**Engineering Statement
Comments in RM-11620
March 2011**

This Engineering Statement has been prepared on behalf of Owens One Company, Inc. ("Owens") in support of comments being filed in response to a Public Notice dated February 18, 2011, which solicited comments on RM-11620, a Petition for Rulemaking filed by Calvary Chapel of Costa Mesa, Inc. ("Calvary").

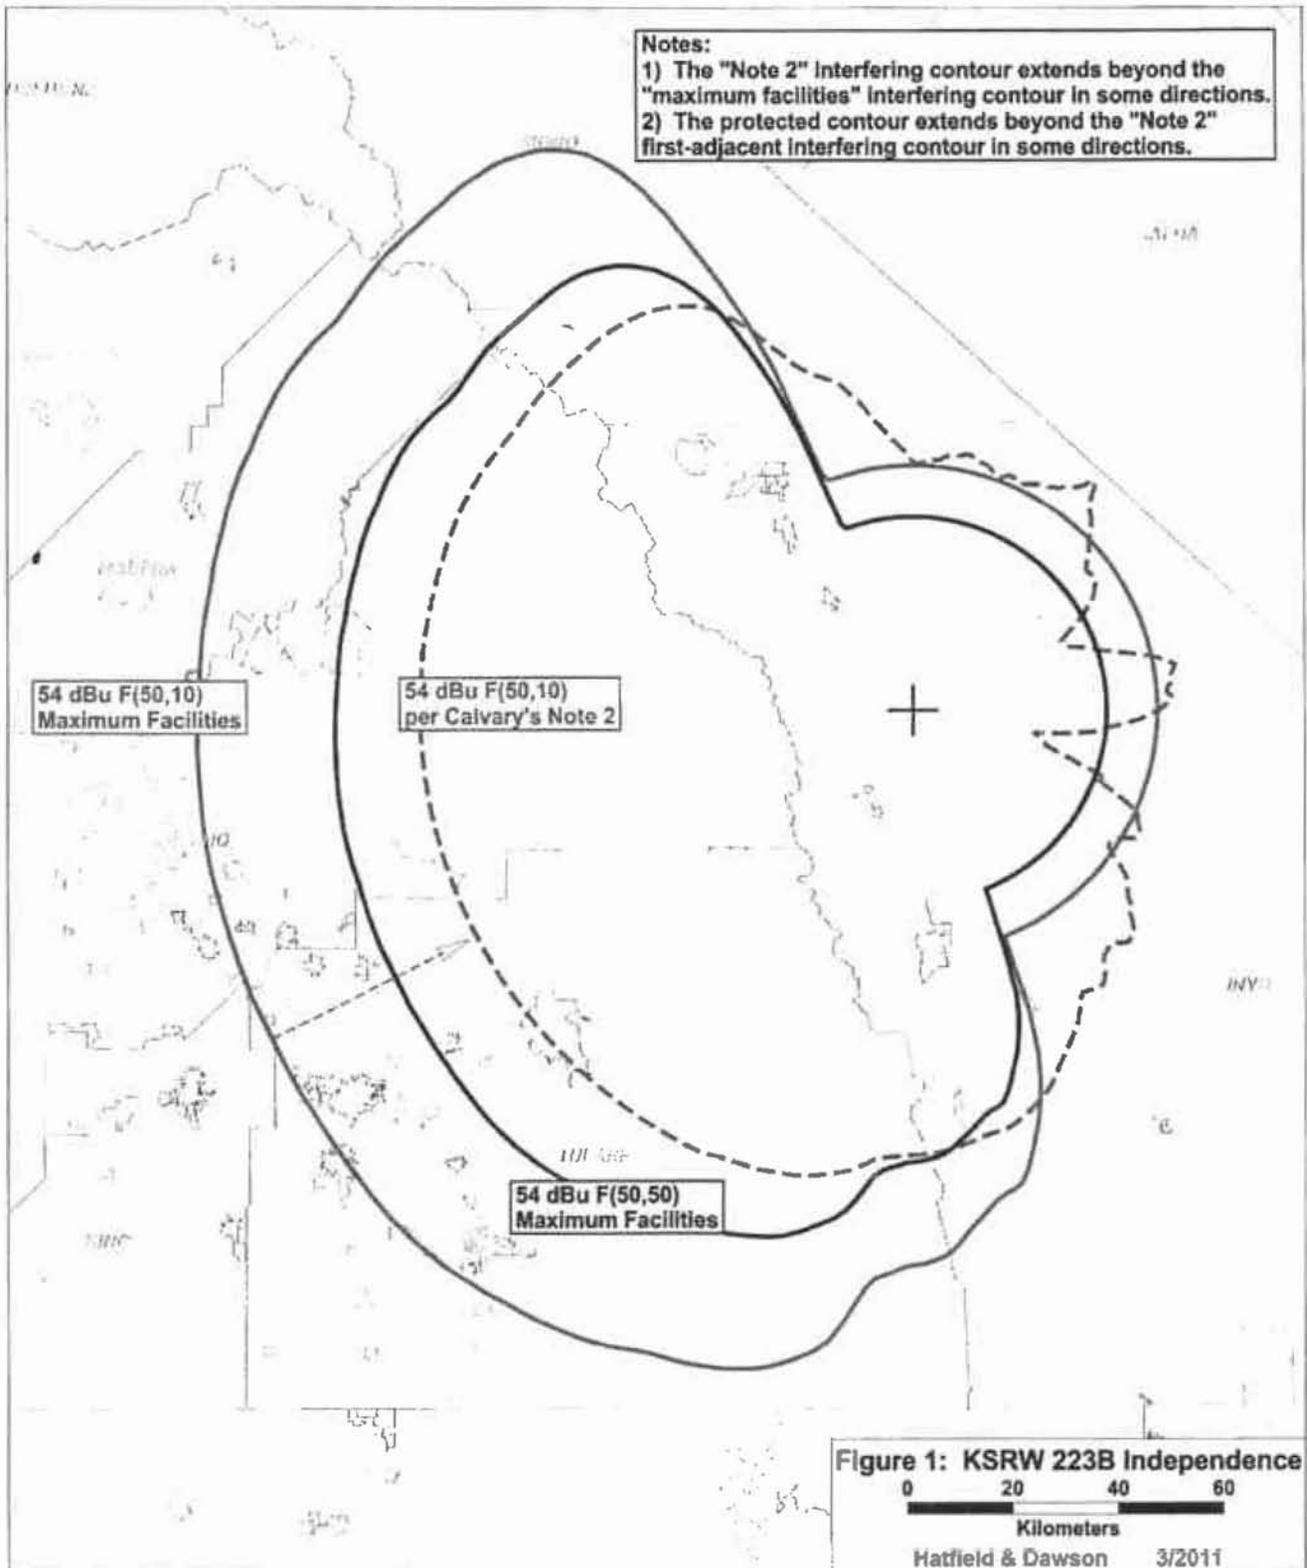
Notes:
1) The "Note 2" interfering contour extends beyond the "maximum facilities" interfering contour in some directions.
2) The protected contour extends beyond the "Note 2" first-adjacent interfering contour in some directions.

Figure 2: KFSO-FM 225B Visalia

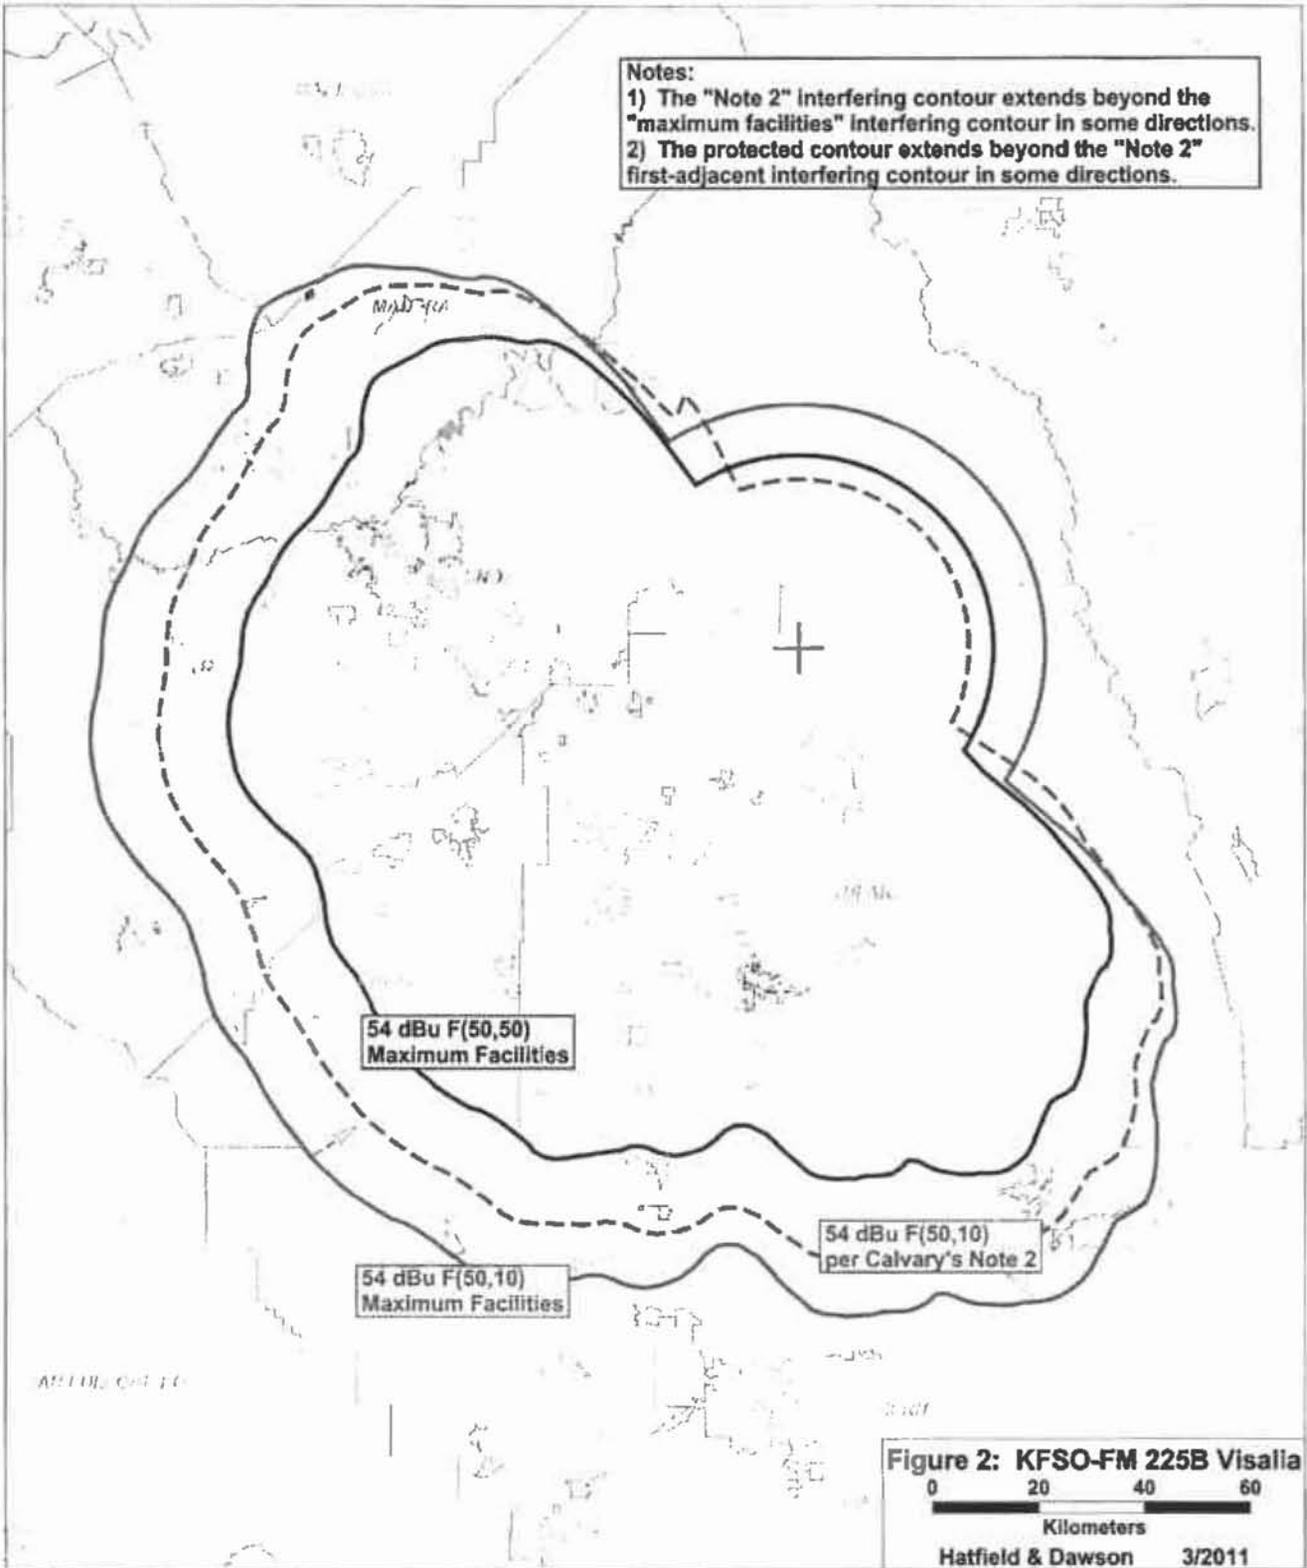
Notes:
1) The "Note 2" interfering contour extends beyond the "maximum facilities" interfering contour in some directions.
2) The protected contour extends beyond the "Note 2" first-adjacent interfering contour in some directions.
